# REGIONAL REVIEW NOTIFICATION

**ARC REVIEW CODE:** R2102261

**Name of Proposal:** Mayson Avenue Development (DRI #3235)

**Description:** A Development of Regional Impact (DRI) review of a proposed mixed-use project directly east of the Edgewood-Candler Park MARTA station in the City of Atlanta (DeKalb County). The proposal includes 450 multifamily apartment units, 275 townhomes/condos, and 10,000 SF of retail space. The local trigger is a rezoning from I-2 (industrial) to PD-MU (Planned Development-Mixed Use). Expected buildout is 2023.

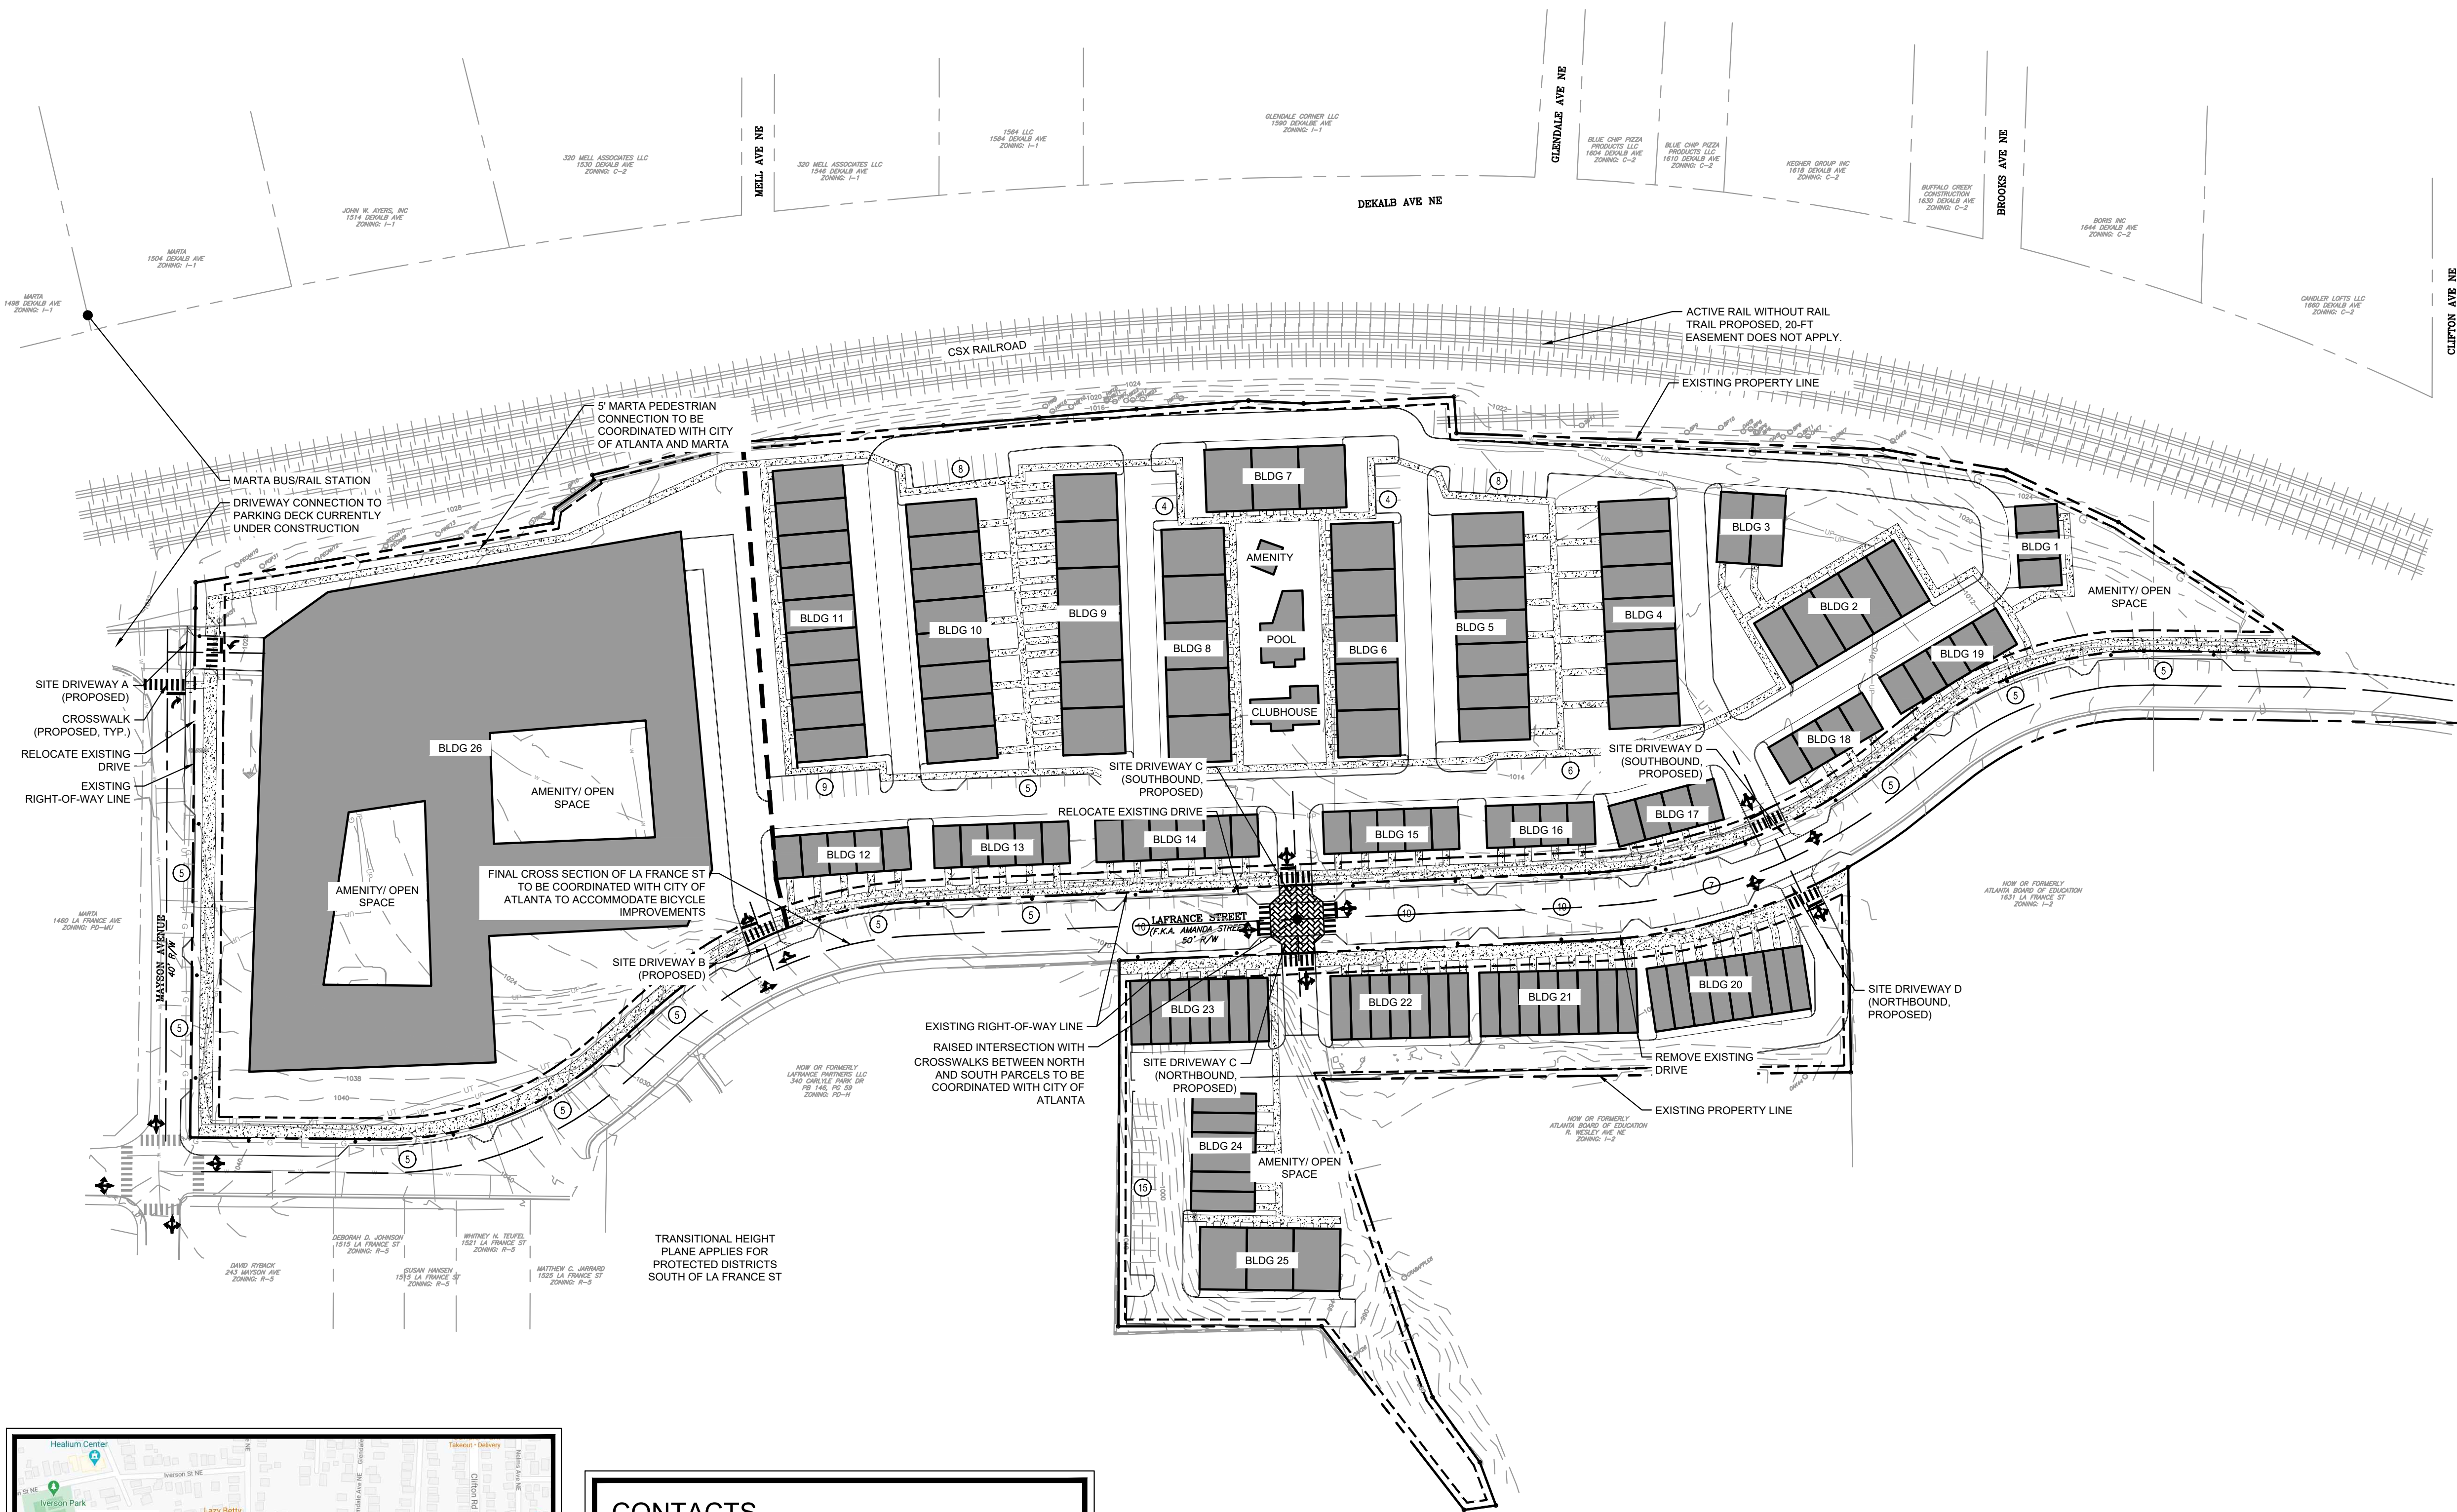
The DRI proposes 890 parking spaces, when only 565 parking spaces are required by zoning. As a site adjacent to a MARTA station, the site should follow MARTA's TOD guidelines, which recommend a minimum of 0.75 spaces per unit and a maximum of 1.25 spaces per unit for multifamily and attached residential units within 600 feet of a transit station. The proposed parking ratio is roughly 1.2 for the residential uses, plus about 18 spaces for the retail. This DRI falls within this range, but it's worth noting that since MARTA's TOD guidelines were issued in 2010, there are many more example projects and supporting data nationwide on parking ratios necessary to support transit usage and the needs of the tenants. The orientation of the DRI's parking generally fits with MARTA's TOD guidelines and the City's requirements for this type of zoning, however electric charging facilities should be included within all residential garages and opportunities for public charging facilities should be identified.

There is an opportunity and ample right-of-way to build a quality protected bike facility, on-street parking, bulb-outs, crosswalks, and other traffic calming features to improve the street's urban character and service to the MARTA station as the uses surrounding it evolve. The existing wide right-of-way was necessary for larger truck traffic serving the manufacturing use, but encourages higher driving speeds. The feasibility of a curb- or parking-protected bike facility along the full frontage of the DRI should be considered in coordination with Atlanta Department of Transportation. Careful attention will need to be paid to visibility and safety on the western portion of the frontage, where the street curves and climbs as it approaches Mayson Avenue.

The project proposes four new driveways: One on Mayson Avenue across from the MARTA station, and the other three on La France Street. During the Pre-Review/Methodology meeting for this project on Jan. 19, 2021, a representative from MARTA raised a question about the orientation of the Mayson access possibly conflicting with bus circulation. The design and location of this access should be coordinated with MARTA's bus operations staff. The driveways on LaFrance should be designed to Atlanta DOT standards by incorporating raised pedestrian tables that eliminate the need for ADA ramps. Additional comments from ARC's Transportation Access and Mobility Group are attached.

- The design of the Mayson Avenue connection turning radii for MARTA bus operations.
- The feasibility of a curb- or parking-protected bike facility along the full frontage of the DRI
- Incorporating green infrastructure and/or low-impact design (e.g., rain gardens, vegetated swales, etc.) in parking areas and site driveways, and as part of any improvements to site frontages.
- Coordination with housing assistance providers to promote mixed income housing.
- Examine parking reductions to be closer to the zoning requirements.
